Floating duplex owner on NE Bridgeton Road

Re: USACE Feasibility Study Comment

Integrated Feasibility Report and Environmental Assessment

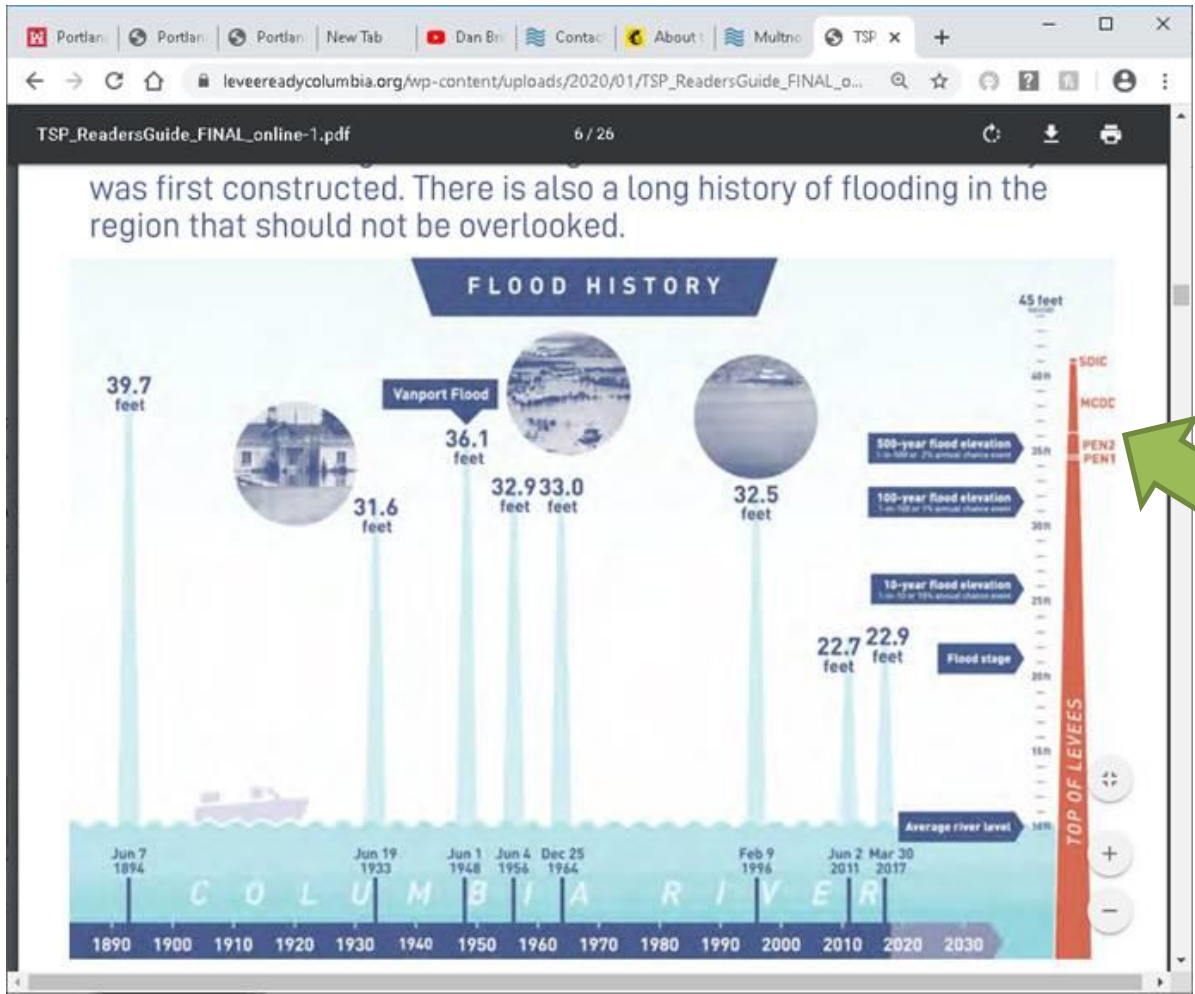
3. Alternative 4 would keep PEN 2 at approximately 35'+ that is already at the 500yr (AEP 0.2) level.

- In a meeting, a MCDD employee stated we are not at the 500yr flood level in PEN 2, yet MCDD's Flood History graph (above) from their Reader's Guide shows we are at the 500yr flood level. Again, the attendees left with the wrong impression and there is no easy way to correct this misinformation.

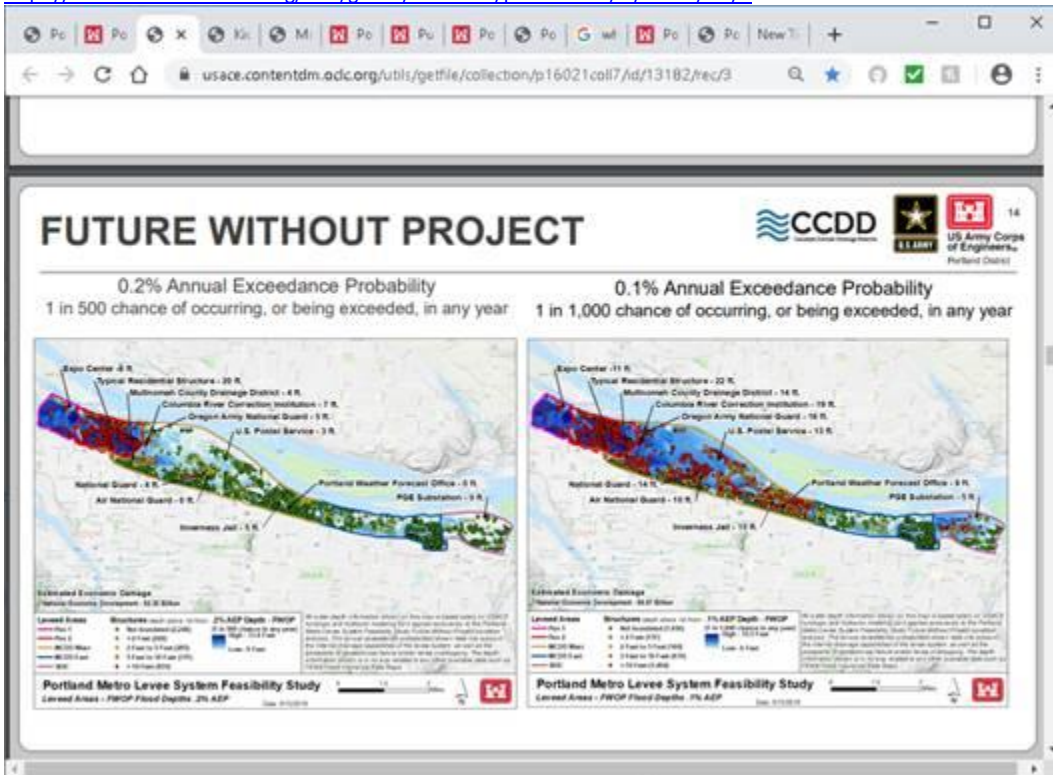
4. Alternative 5: What AEP flood risk is it designed to handle? Is it equivalent to a 2,500yr flood? Or, in other words, a 4 in 10,000 chance of a 40' flood level. Is this a reasonable goal for the USACE?

- It would have been useful to have the model results for Alternative 4 and Alternative 5. Otherwise, there is not enough information to make an informed opinion regarding how these alternatives would help mitigate flood events.

- Sandy's floodwall at 40'. Does having the Sandy River on their east border have anything to do with the higher wall requirements for Sandy?
- Above model shows a 1,000yr (0.1 AEP) model and, in general, Sandy is not flooding. If Bridgeton Road is to be at 40' just to be uniform with Sandy, what AEP is that?

Is my **guess/estimation** of a AEP 0.04 correct? or in old terminology, a 2,500yr flood?
